GROUP	MODEL
<b>Noncompliance Safety Recall Campaign</b>	<b>2026MY Sorento (MQ4a)</b> <b>2025MY Telluride (ON)</b>
NUMBER	DATE
<b>SC355</b>	<b>October 2025</b>

### SPARE WHEEL AND TIRE ASSEMBLY REPLACEMENT (SC355)

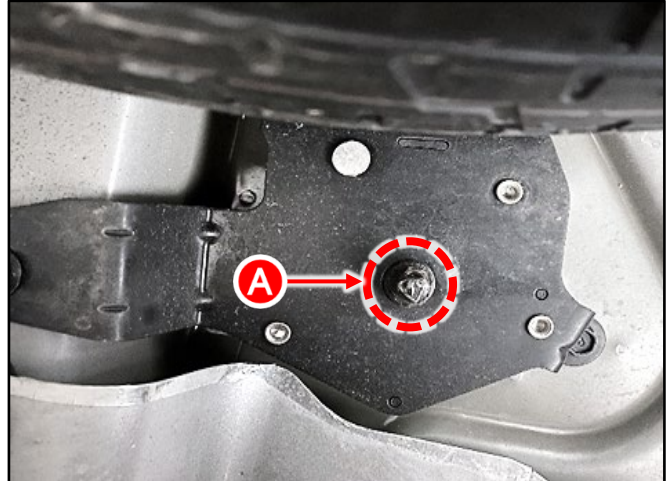
1. Using a ratchet and 3/8" socket, loosen the spare wheel and tire assembly retaining bracket bolt (A) to remove the incorrect spare tire and wheel assembly.

Use a hand tool to remove the bolt (A). Do not use an impact gun.

2. Install the correct spare tire for the applicable model.

Tightening torque for bolt:  
21.7 - 25.3 lb.ft (28.5 - 34.32 N.m)
